SEPP 65
Assessment

SEPP 65 PEER ASSESSMENT REPORT

For Hawkesbury City Council

Issue B – FINAL – February 2018

Figure 3.1 - Excerpt from the RAAF Base Richmond 2014 ANEF Summary Report, showing the ANEF zones and the approximate location of the subject site, indicated by the red star. The site is located within the ANEF 25 and ANEF 30 contours.

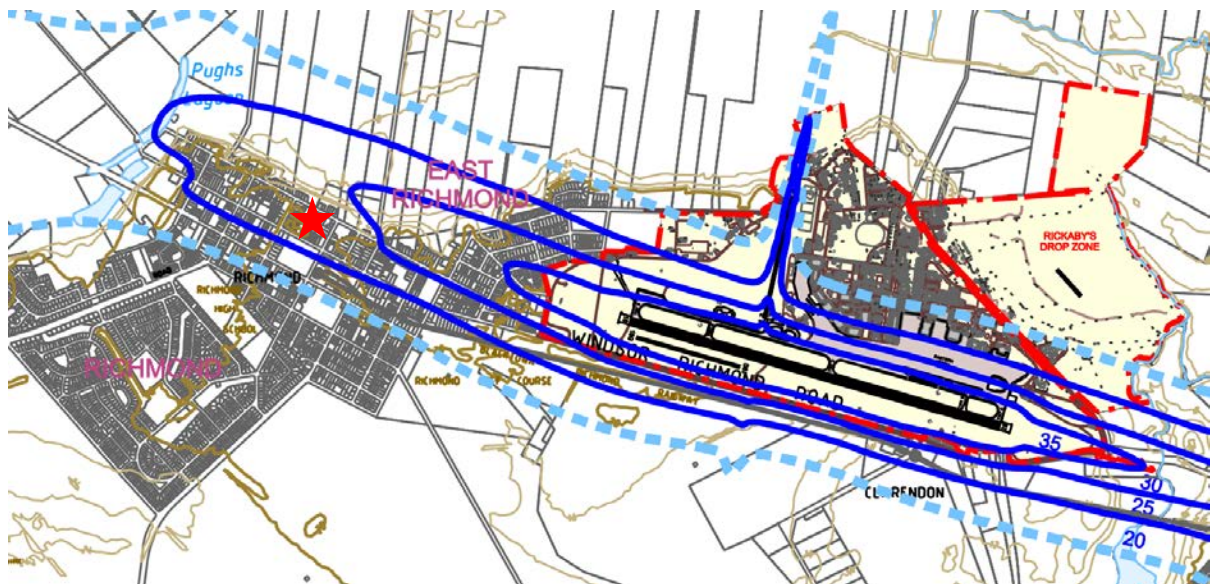
The Traffic Noise and Aircraft Noise Assessment prepared by Rodney Stevens Acoustics in November 2017 provides recommendations for the acoustic requirements for the proposed development based on an assessment of the site being located within the ANEF 20 – 25

contours. As the site is located between the ANEF 25 – 30 contours, further consideration is required in terms of the suitability of the site for this type of residential developments and the acoustic treatments that would be required to achieve an acceptable level of amenity for residents.
